City of Seattle

STANDARD SYMBOLS  
PRIVATE UTILITIES

CONNECTIONS TO EXISTING WATERMAINS

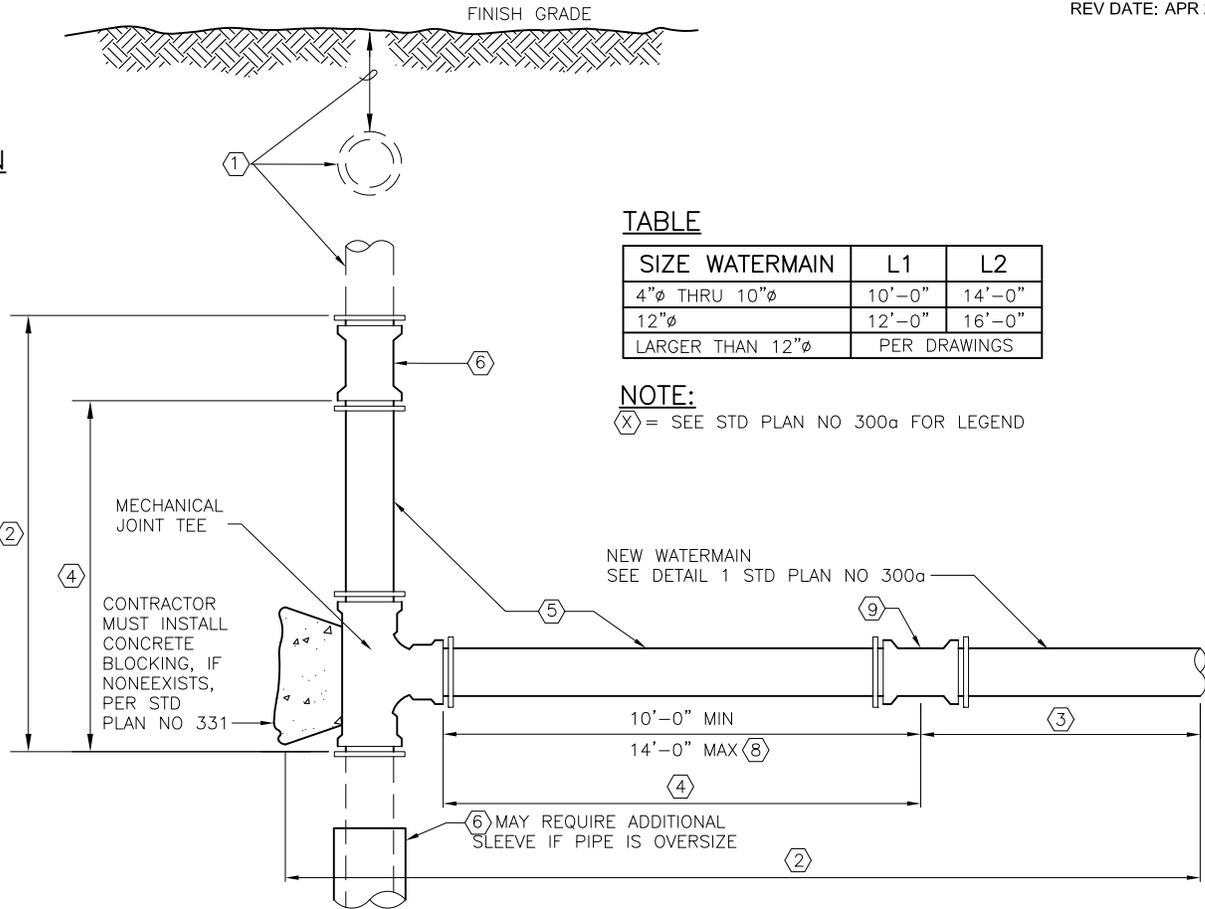
revised

CONNECTIONS TO EXISTING WATERMANS

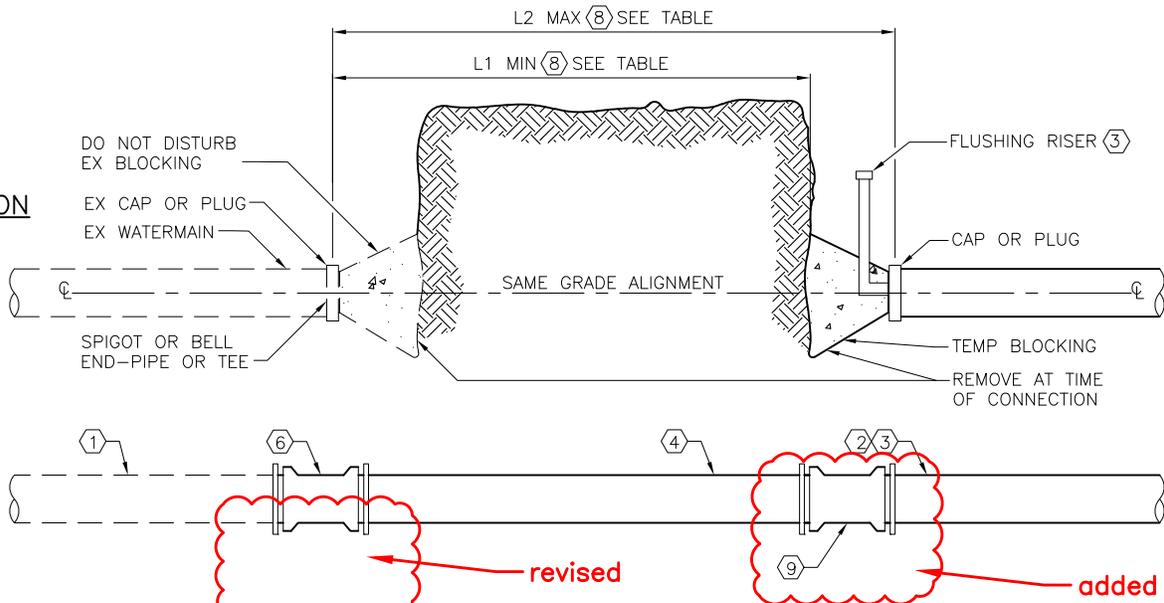
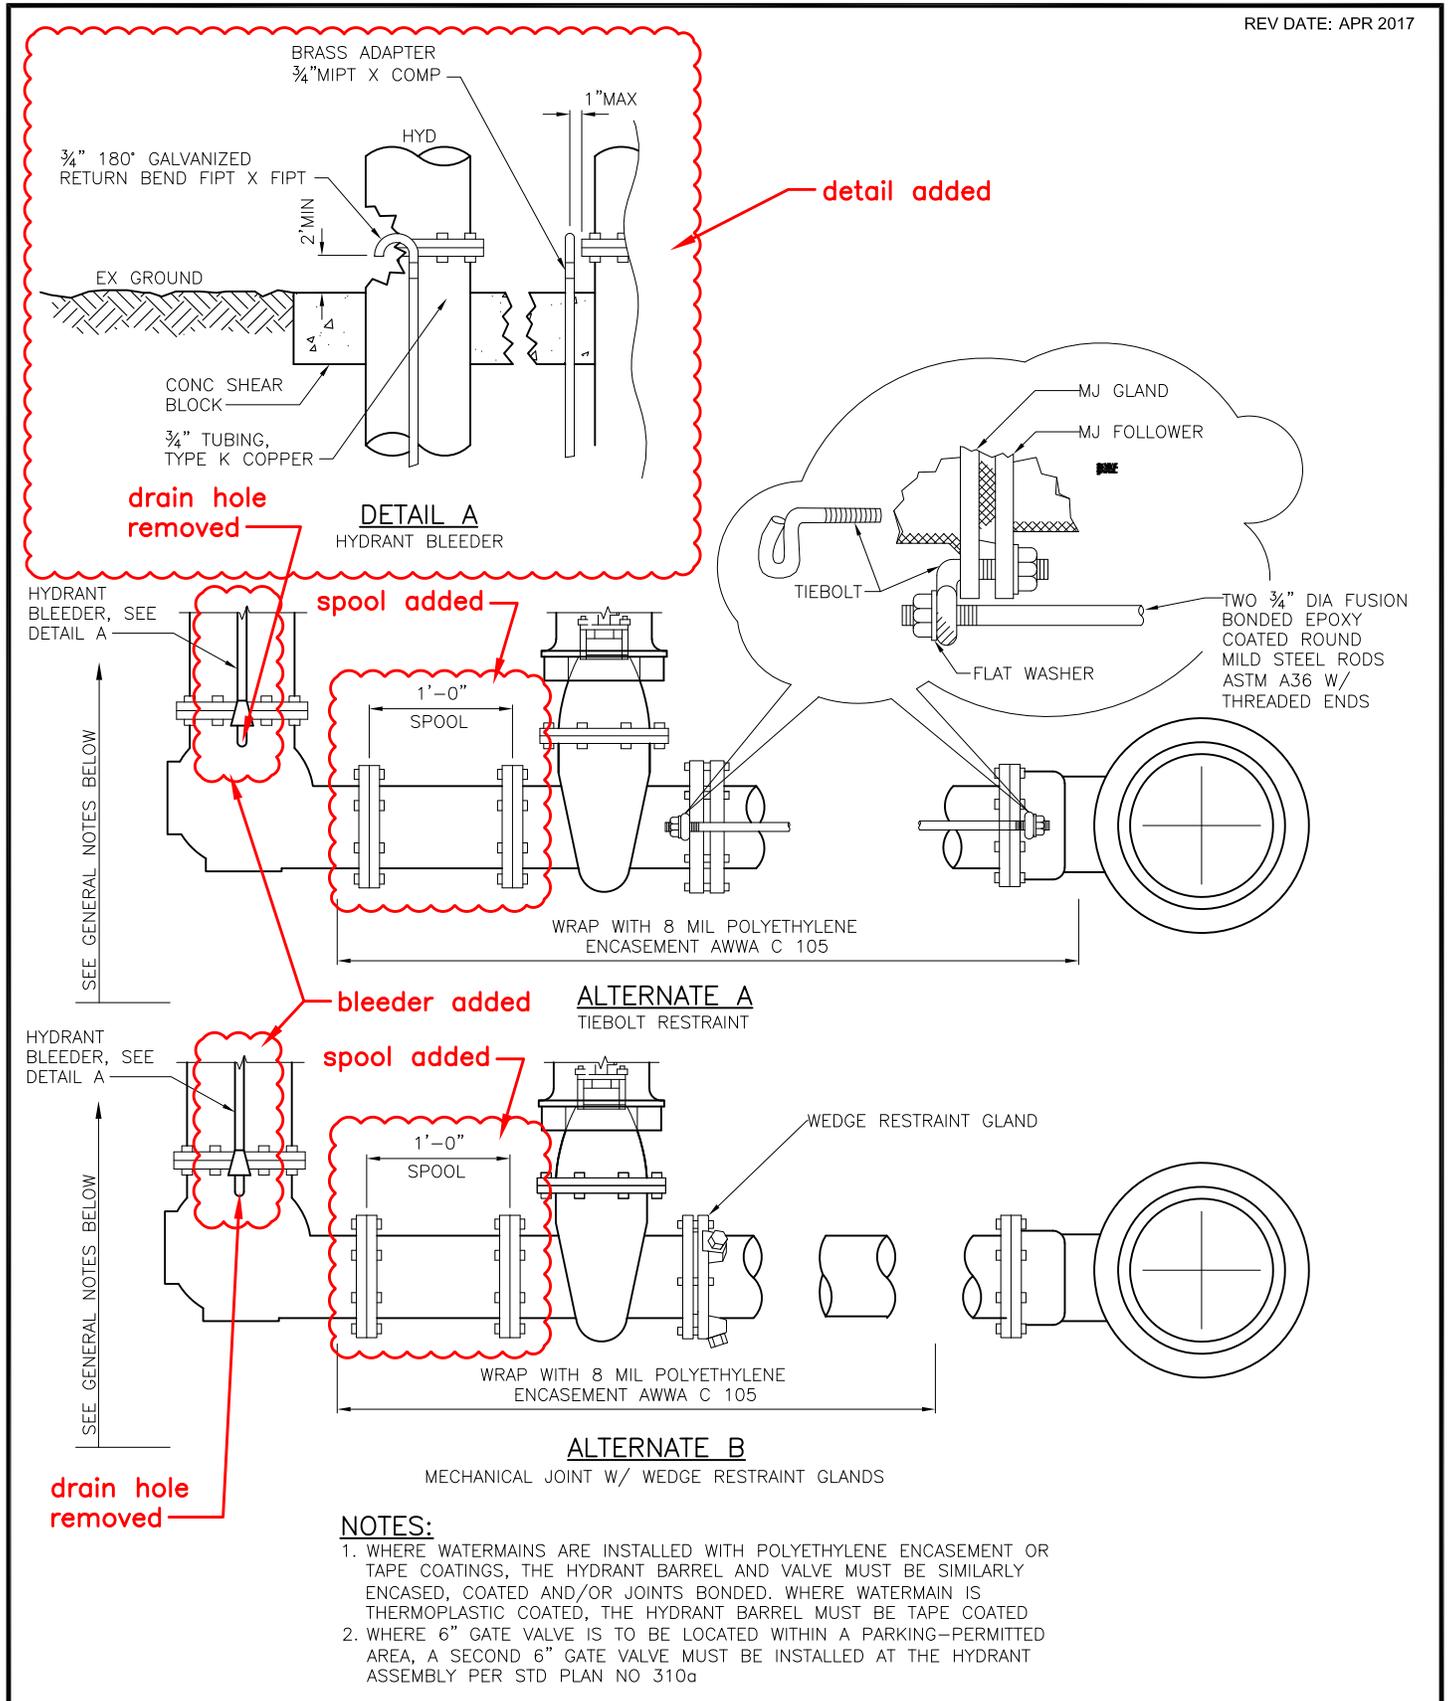
revised

added

WATERMAIN THRUST BLOCKING HORIZONTAL FITTINGS

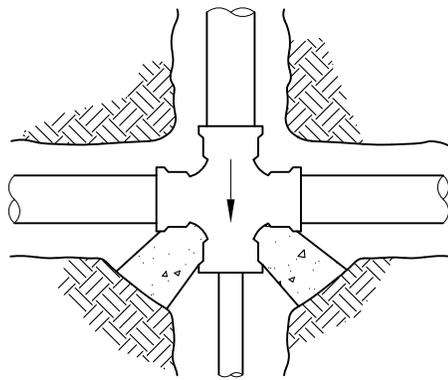
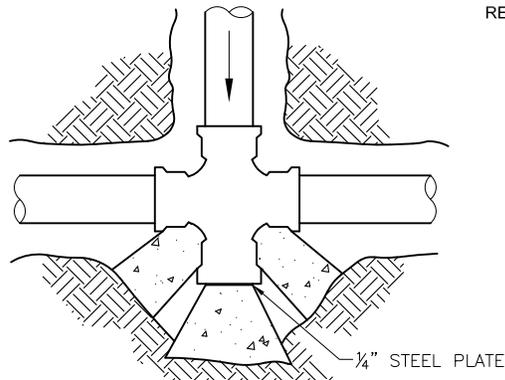
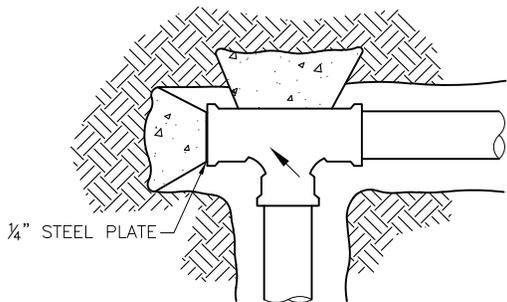
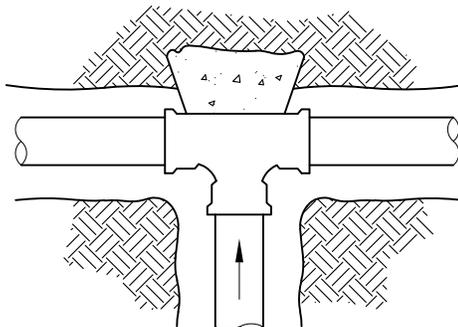
note revised

"SHALL" changed to "MUST"

ECOLOGY BLOCKS, PER STD PLAN NO 460, MAY BE USED, AT THE DISCRETION OF THE ENGINEER ONLY, IN LIEU OF POURED-IN-PLACE BLOCKING FOR FITTINGS IN HEAVY OUTLINED PORTION OF TABLE. ECOLOGY BLOCKS USED FOR THRUST BLOCKING AT TEES MUST TRANSFER LOAD TO THE PIPE BODY PER SPEC SECTION 7-11.3(13).

**DIRECTIONAL CURB RAMPS**  
(TYPE 422D)

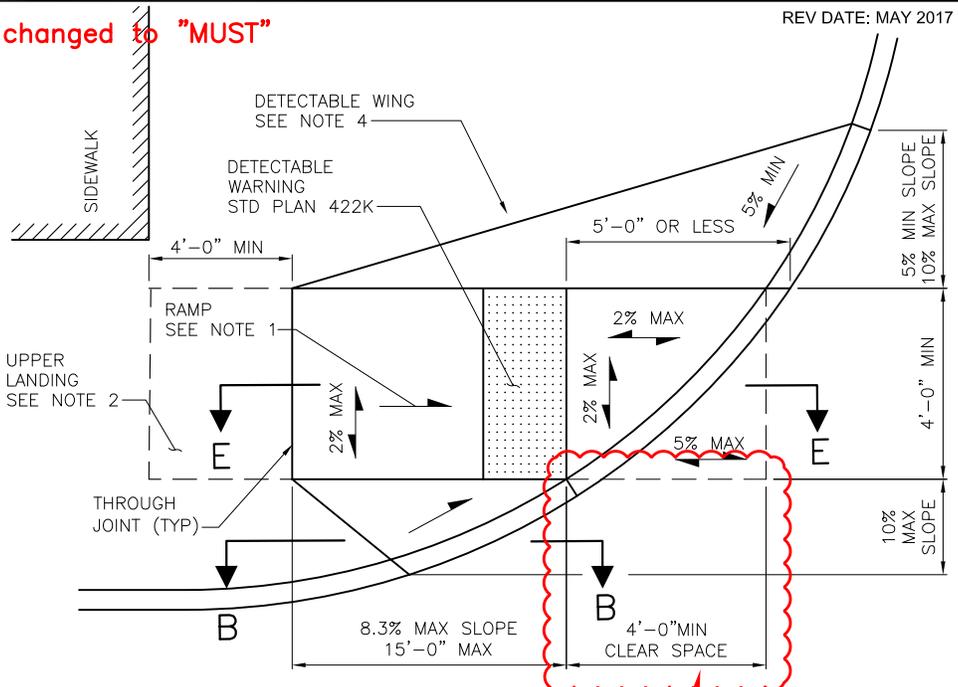
"SHALL" changed to "MUST"

upper landing removed

dimension added

dimension added

**DIRECTIONAL CURB RAMPS**  
(TYPE 422E)

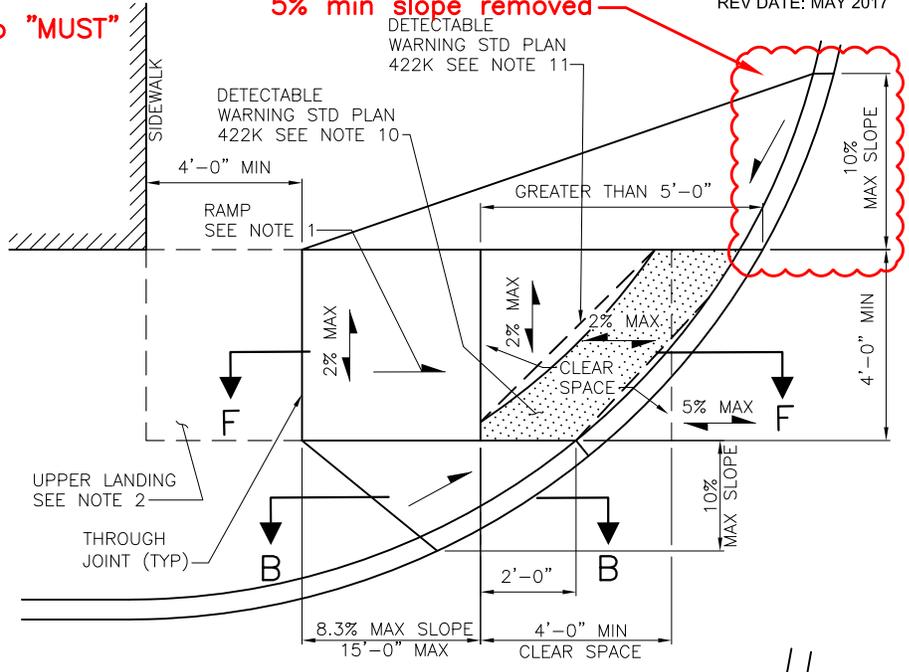
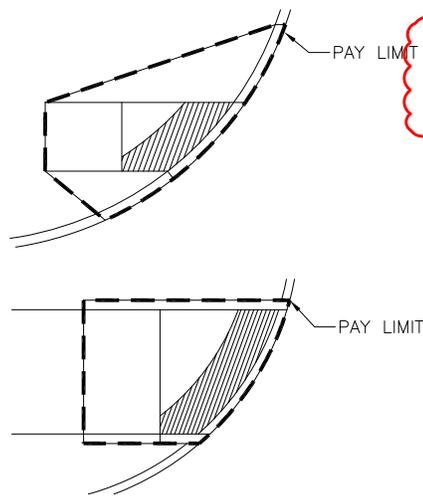
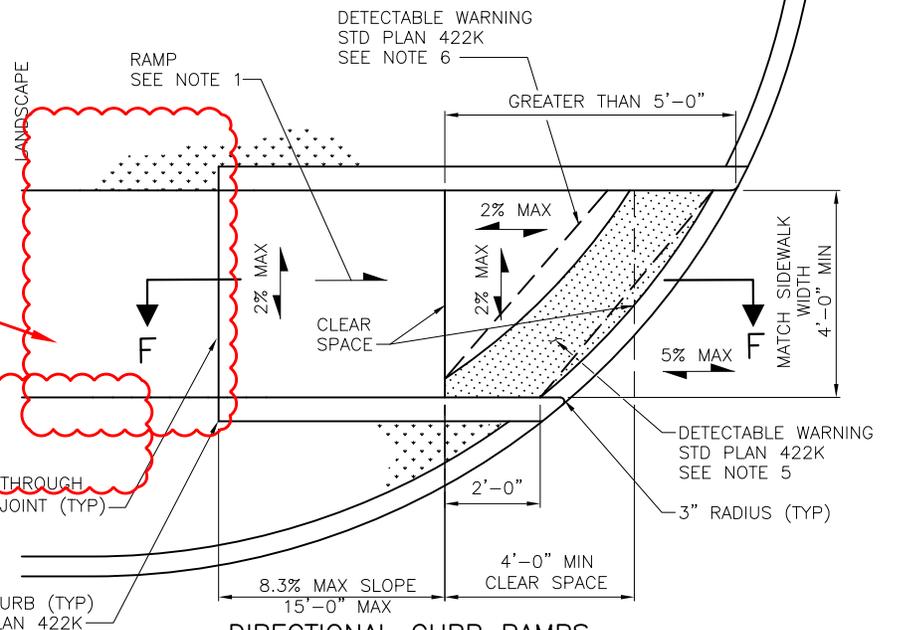
"SHALL" changed to "MUST"

5% min slope removed

upper landing removed

PARALLEL AND PERPENDICULAR COMBINATION CURB RAMPS W/ SHARED LANDING (TYPE 422G)

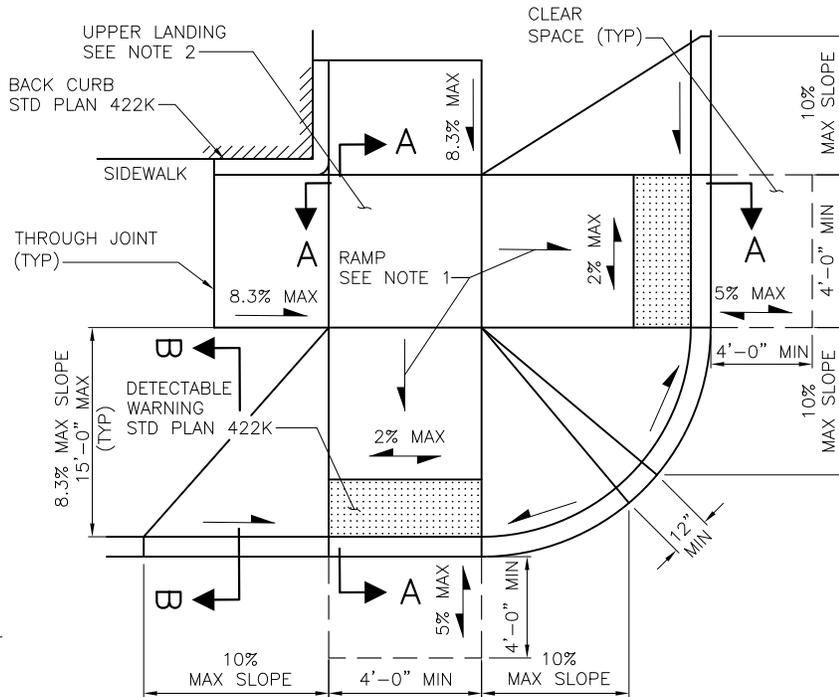
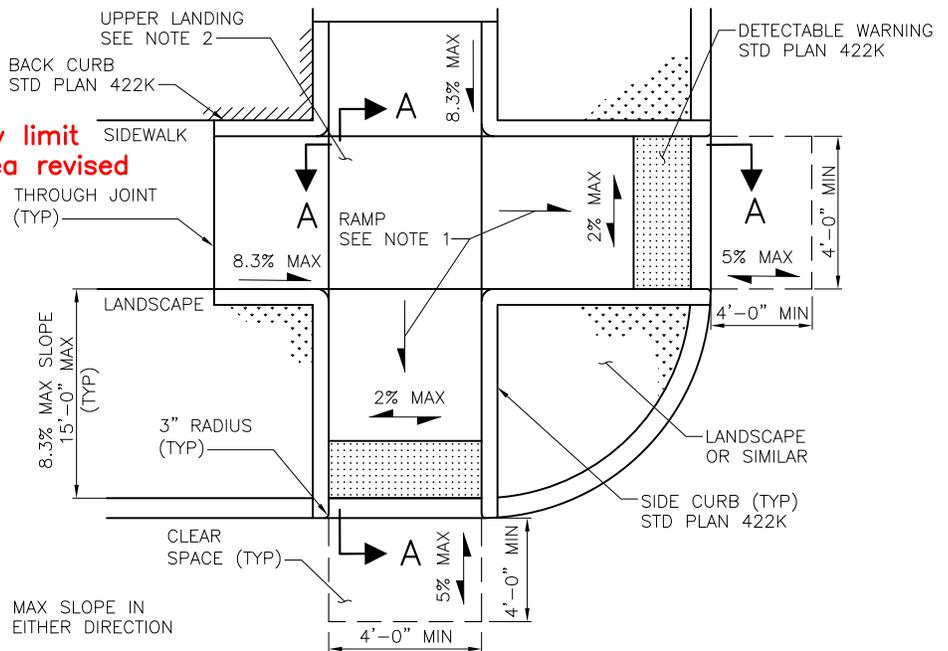
"SHALL" changed to "MUST"

pay limit area revised

**SHARED DIAGONAL PERPENDICULAR CURB RAMP**  
(TYPE 422H)

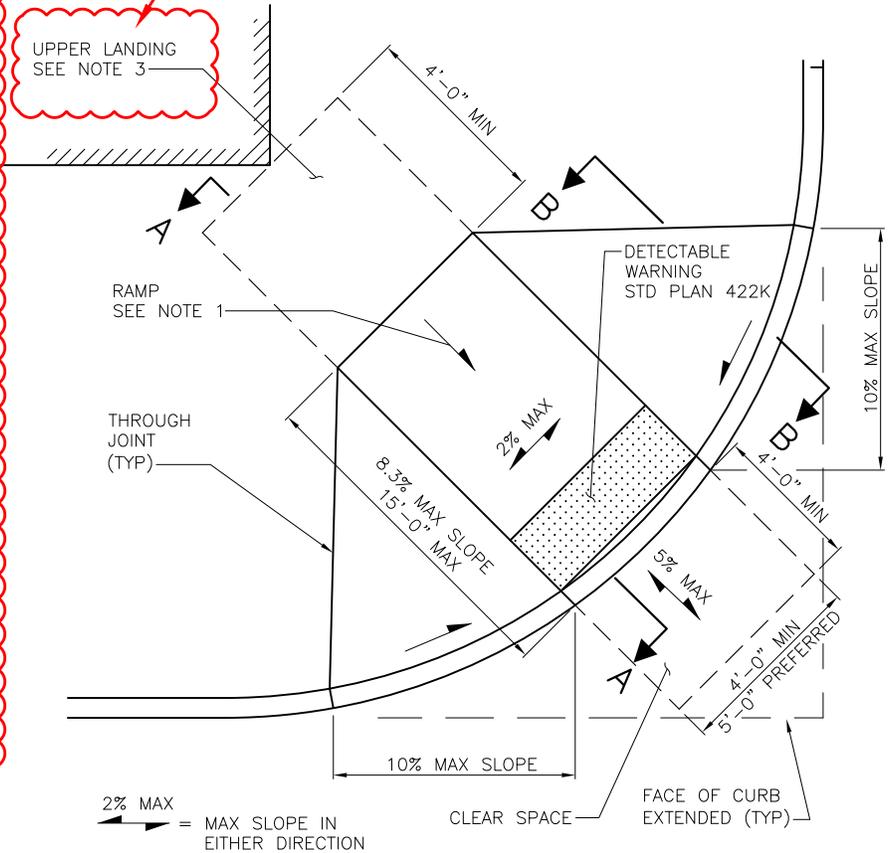
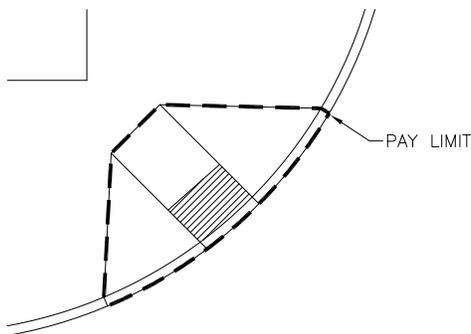
"SHALL" changed to "MUST"

changed to "NOTE 3"

**PEDESTAL TOP MOUNTING**

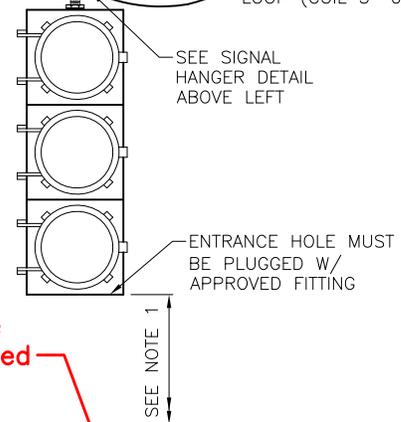
title added

HANDHOLES

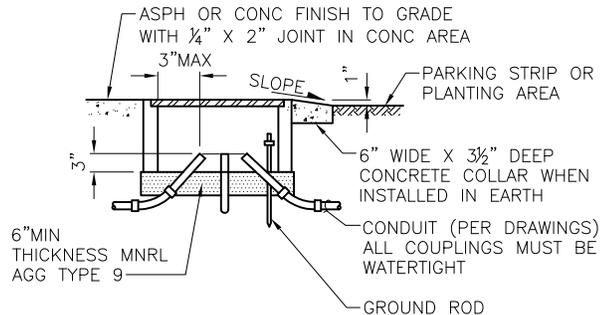
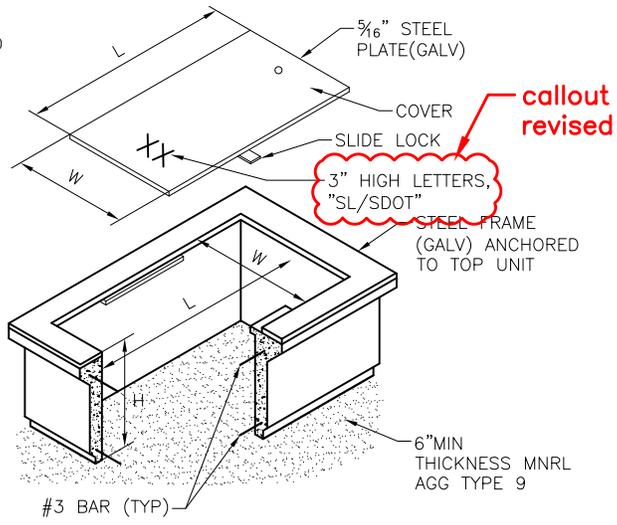
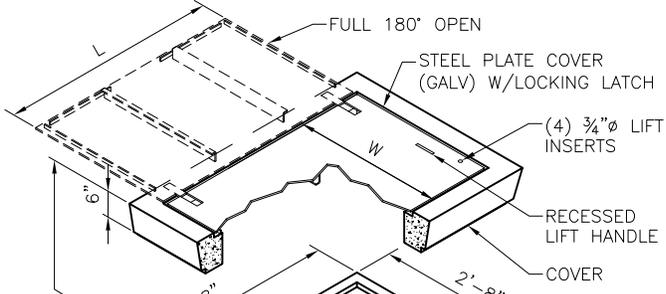
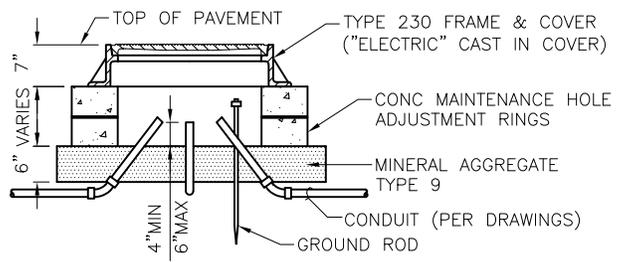
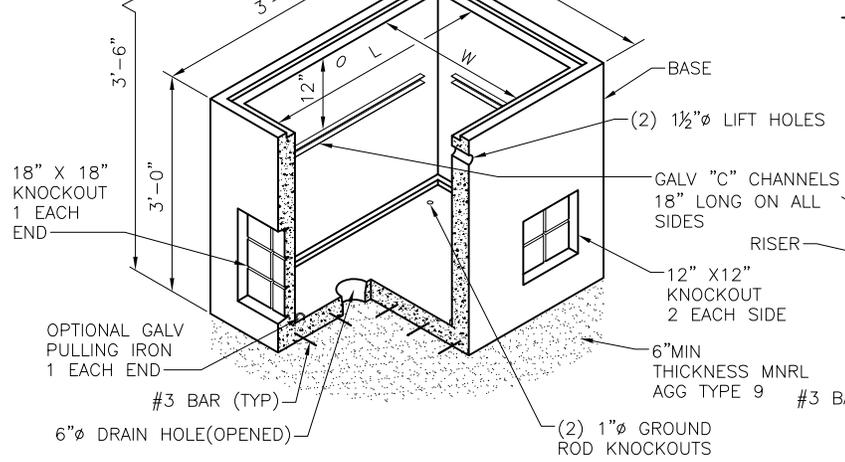
note revised

8. ALL HANDHOLES MUST HAVE A LOAD RATING OF H20.
9. GROUND ROD REQUIRED IN ALL STREETLIGHT HANDHOLES PER SCL CONSTR STD 1710.50
10. SEE SCL CONSTRUCTION STANDARD 1716.07 FOR STREETLIGHT HANDHOLE AND CONDUIT REQUIREMENTS.
